Service Bulletin

Bulletin No.: 17-NA-380

Subject: Rattle Type Noise Heard from Underneath Vehicle

| Cause |  <p>This condition may be caused by the isolator (1) being separated from the cradle hangers (2).</p> <p>4895575</p> |

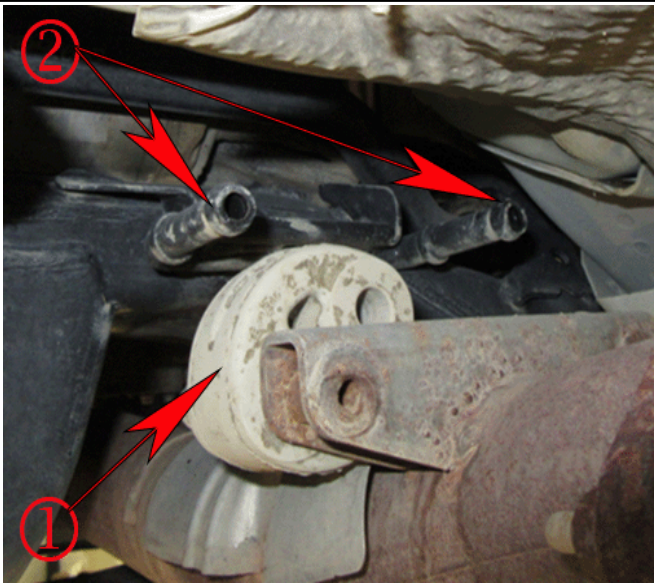
| Condition | Some customers may comment on a rattle type noise heard from underneath the vehicle. |
